**Pacific Gas and
Electric Company**

PG&E Letter DCL-04-149

Docket No. 50-275, OL-DPR-80
Docket No. 50-323, OL-DPR-82
Diablo Canyon Units 1 and 2
License Amendment Request 04-07
Revision to Technical Specifications 3.7.17 and 4.3 for Cycles 14-16 for a Cask Pit
Spent Fuel Storage Rack

FIGURE 3.7.17-1
ALLOWABLE STORAGE CONFIGURATIONS
(ALL CELL, 2X2 ARRAY, CHECKERBOARD)
FOR THE PERMANENT SPENT FUEL POOL STORAGE RACKS

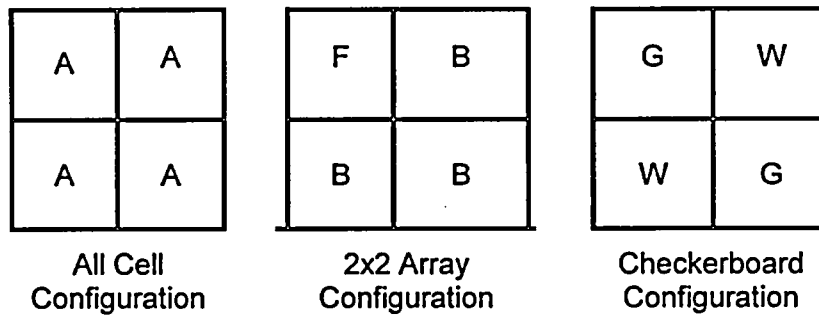
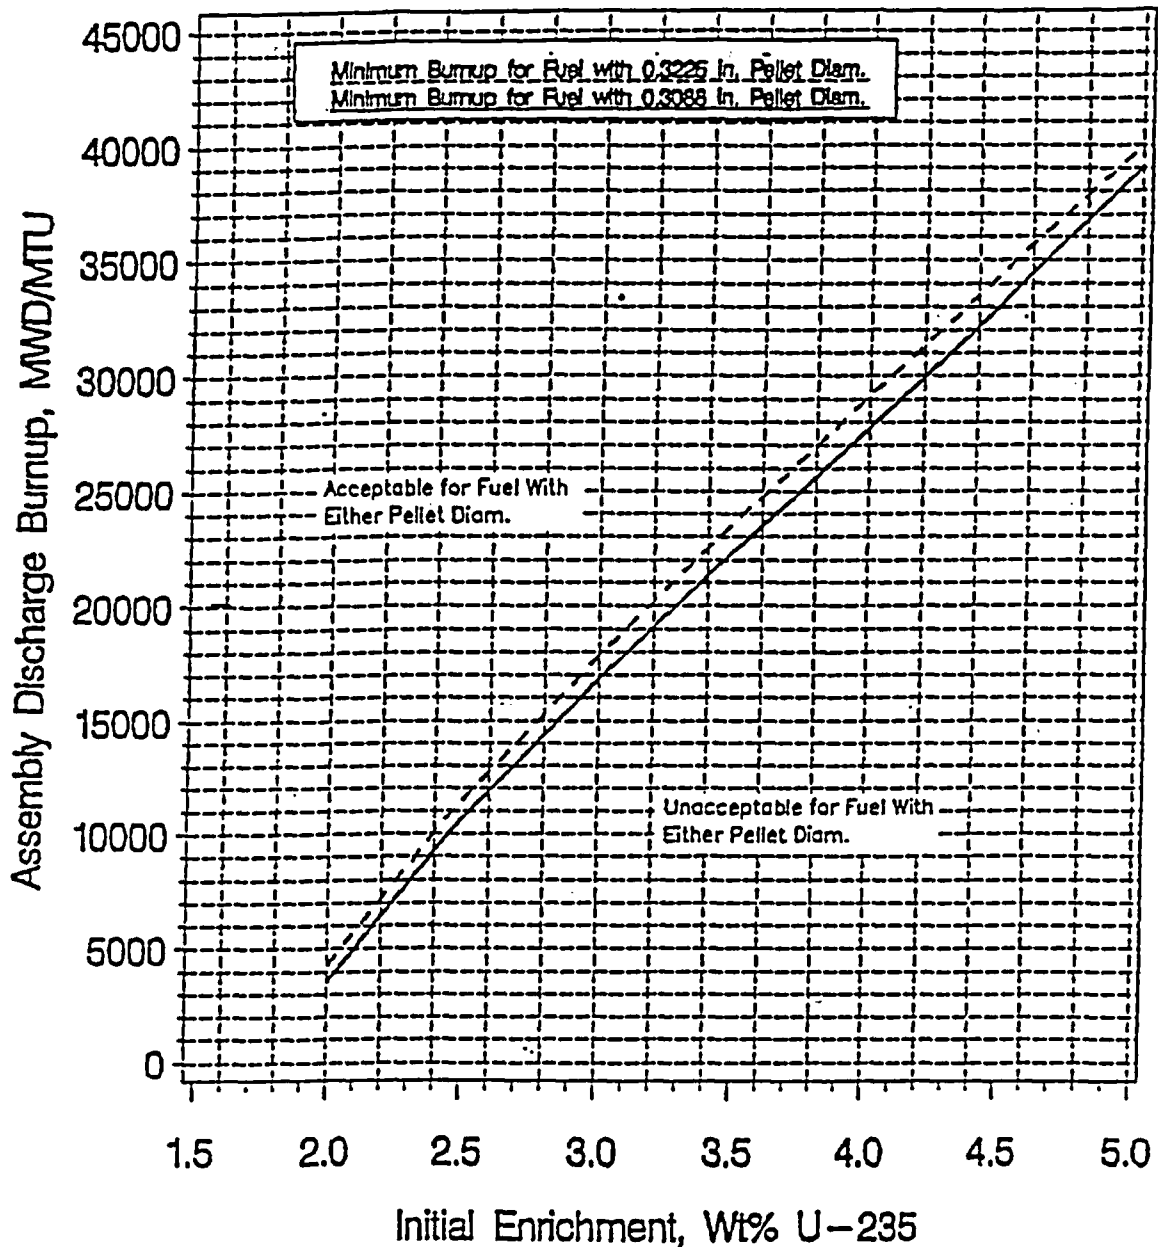
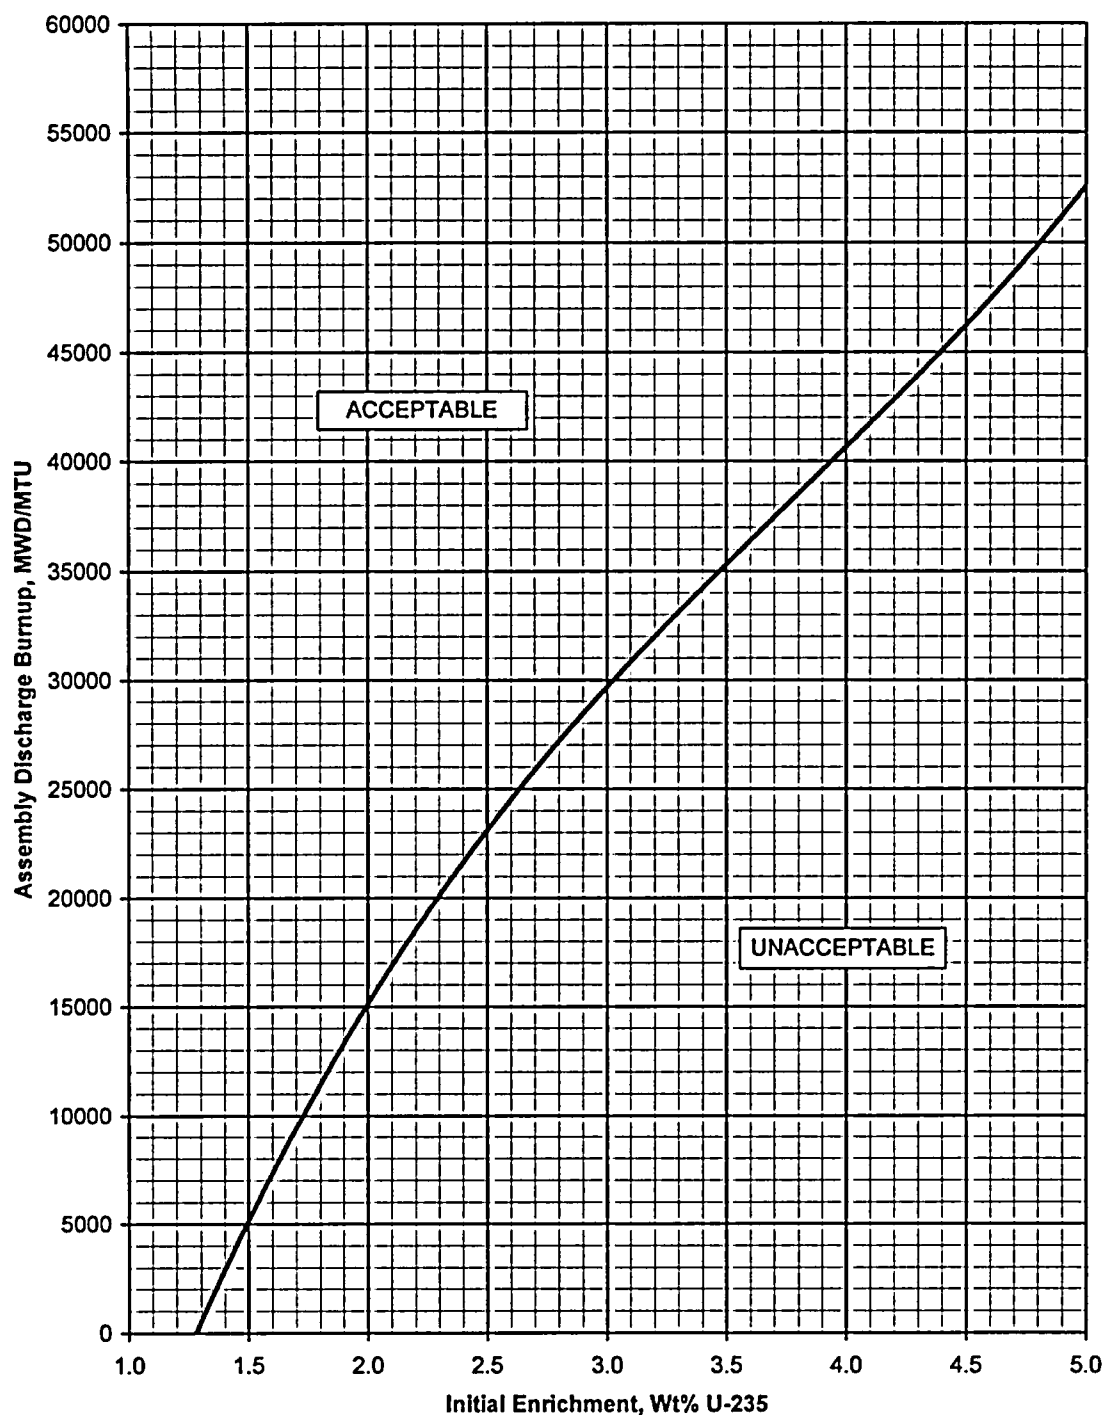
1. TS 3.7.17: LCO 3.7.17 would be revised to add requirements during Cycles 14-16 for a cask pit rack.
2. Figures 3.7.17-1 to 4: Figures 3.7.17-1 to 3 would be changed to note that they are applicable to the permanent storage racks. Figure 3.7.17-4 would be added to provide acceptable/unacceptable enrichment and burnup requirements for the fuel stored in the cask pit rack for Cycles 14-16.

FIGURE 3.7.17-4
MINIMUM REQUIRED ASSEMBLY DISCHARGE BURNUP
AS A FUNCTION OF INITIAL ENRICHMENT
FOR SPENT FUEL STORAGE IN THE CASK PIT STORAGE RACK

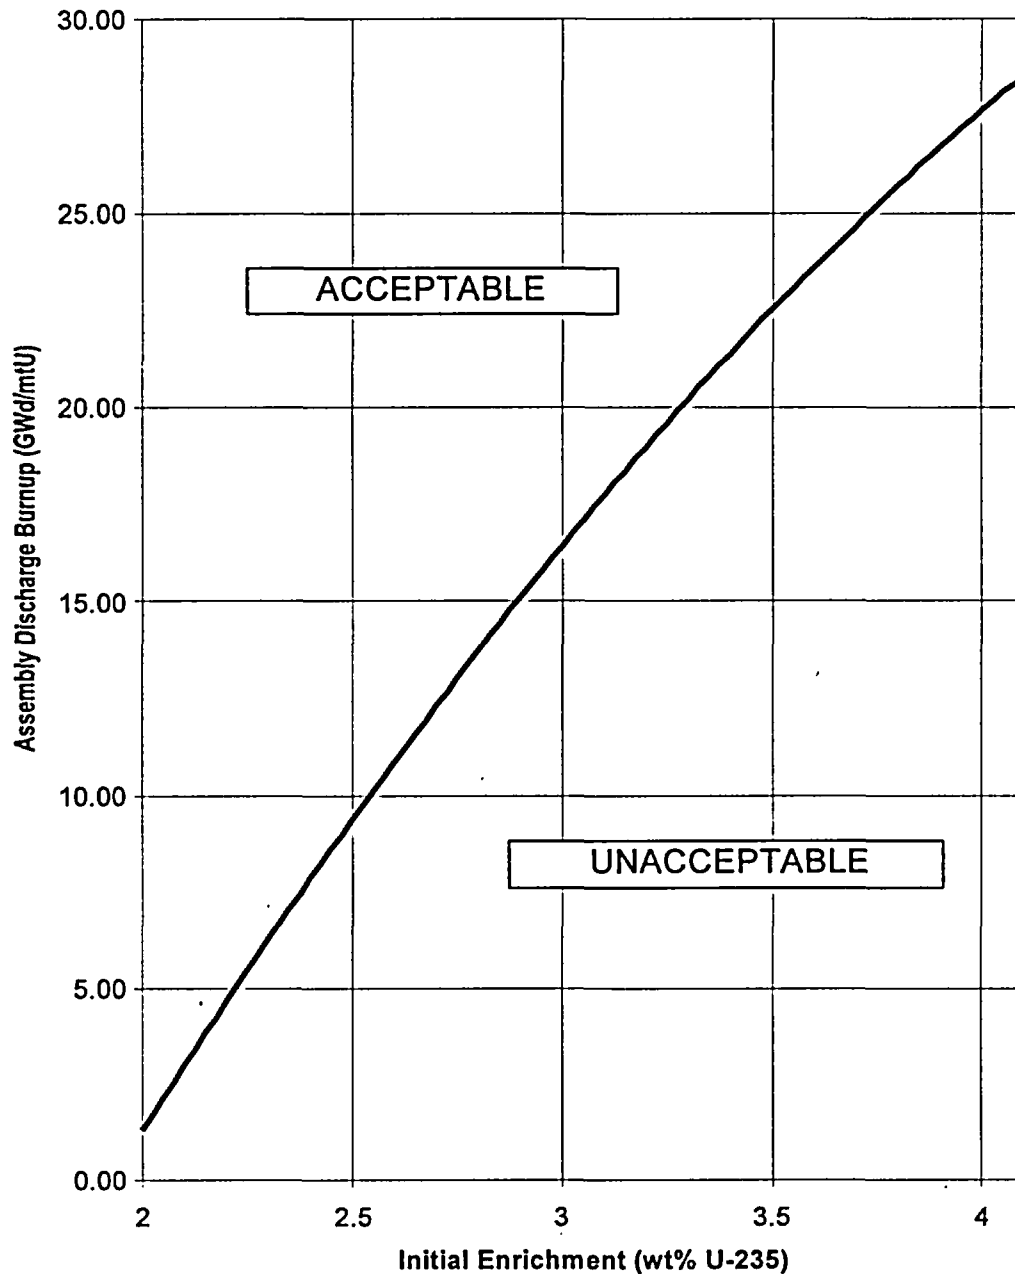
Insert New Figure 3.7.17-4.

The results of the calculations demonstrate that spent fuel assemblies with less than or equal to 4.1 percent initial enrichment and greater than or equal to 28.53 GWD/MTU may be stored in the cask pit rack. In addition, a burnup vs. initial enrichment curve was developed (refer to proposed TS Figure 3.7.17-4), which ensures that storage of applicable fuel meeting these curve limits will maintain the effective neutron multiplication factor (k_{eff}), less than 1.0 with unborated water and less than or equal to 0.95 with borated water.

credit of 800 ppm at a 95 percent probability with 95 percent confidence level. Calculations performed qualify the cask pit racks for storage of burned fuel assemblies with maximum nominal (initial) enrichments and burnup characteristics as shown in proposed TS Figure 3.7.17-4.
